COVER SHEET CIVIL PLANS

PRFO20240367

COVER SHEET CIVIL PLANS
FORTRESS - PUYALLUP
CREF3 PUYALLUP OWNER LLC
11611 SAN VICENTE BLVD
10TH FLOOR
LOS ANGELES, CA 90049

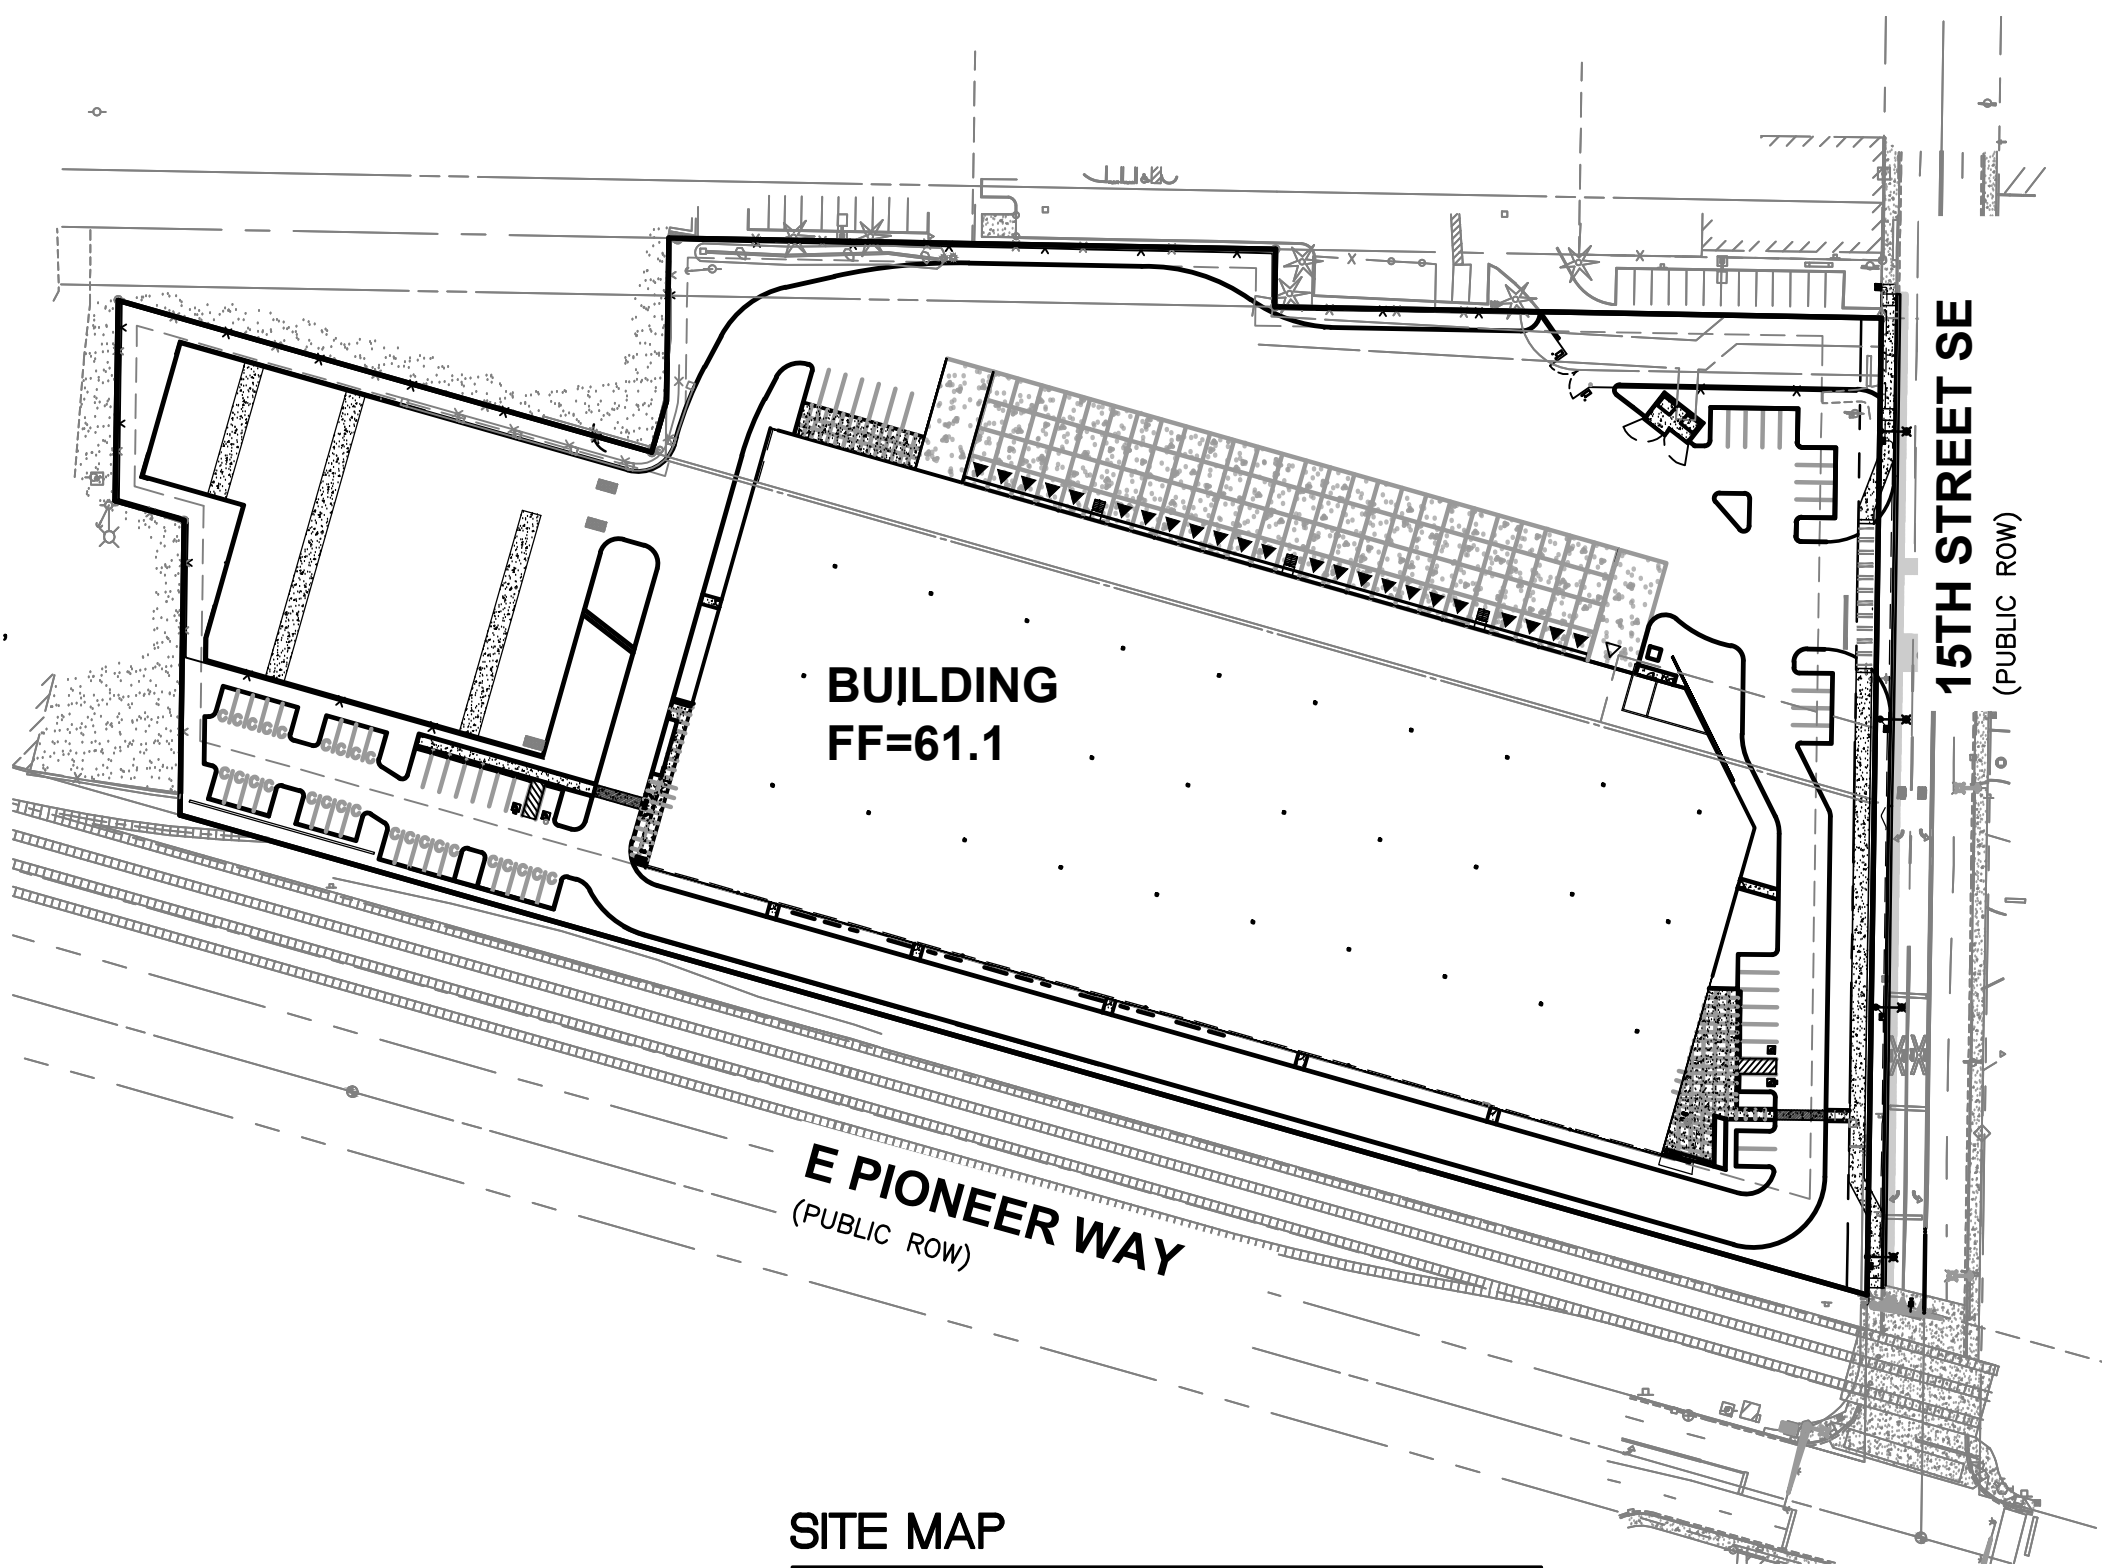
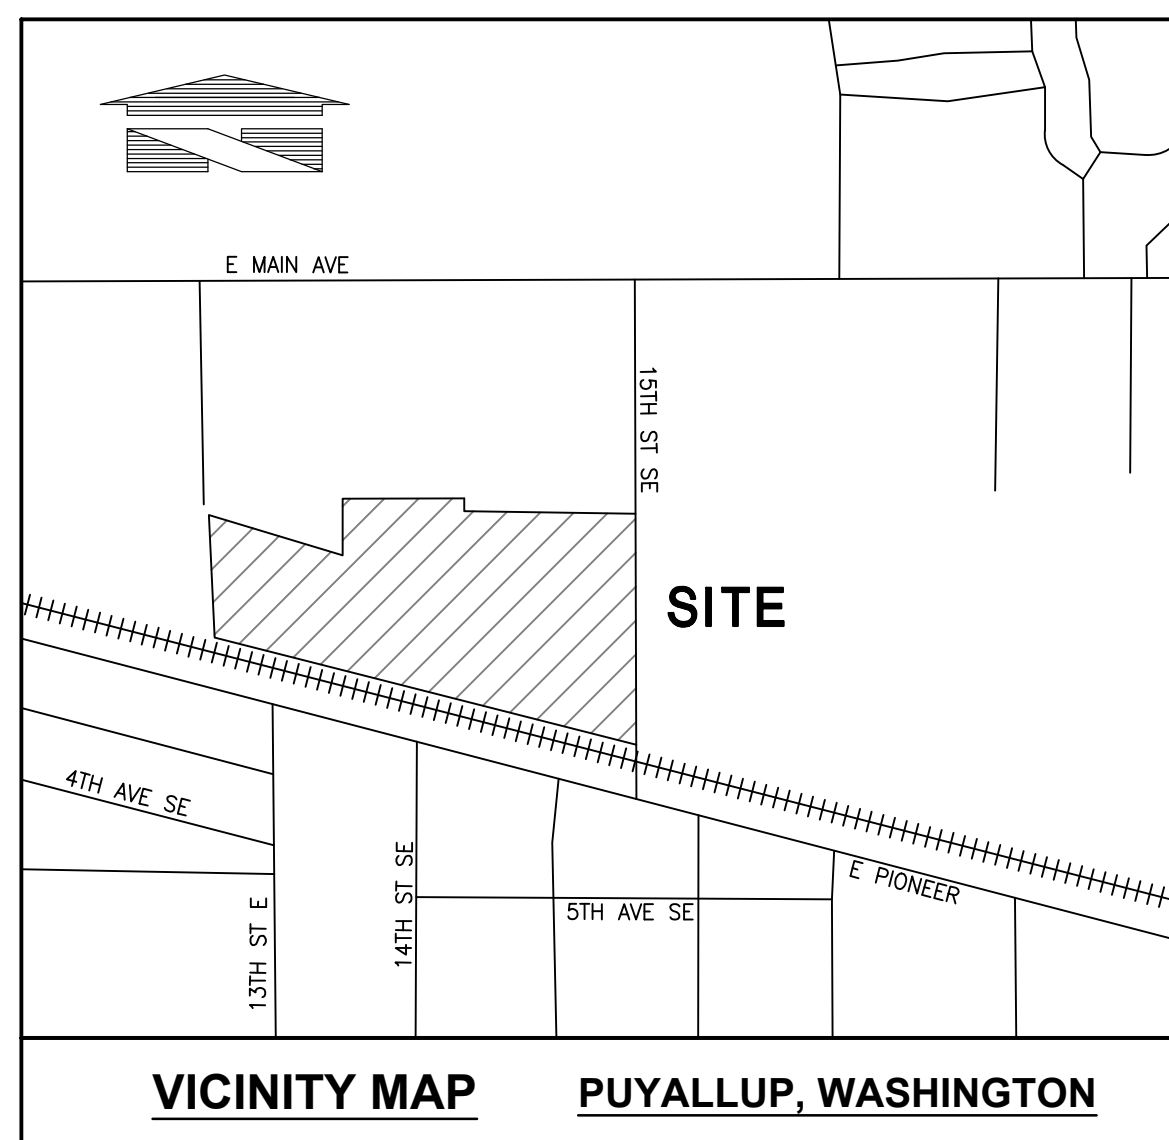
Building permit PRFO20240367 shall not be issued until civil permit PRCCP20231096 and all necessary demolition permits are issued first. The building permit site plan must match the approved civil plans. A final submittal is required to compare the building and civil plans prior to building permit issuance. The applicant shall be responsible for coordinating final building permit submission to avoid redundant reviews and building permit fees. [SITE PLAN, sheet C1]

Building permit PRFO20240367 shall only be used for the construction of the stormwater vault. For all other work, refer to civil permit PRCCP20231096.
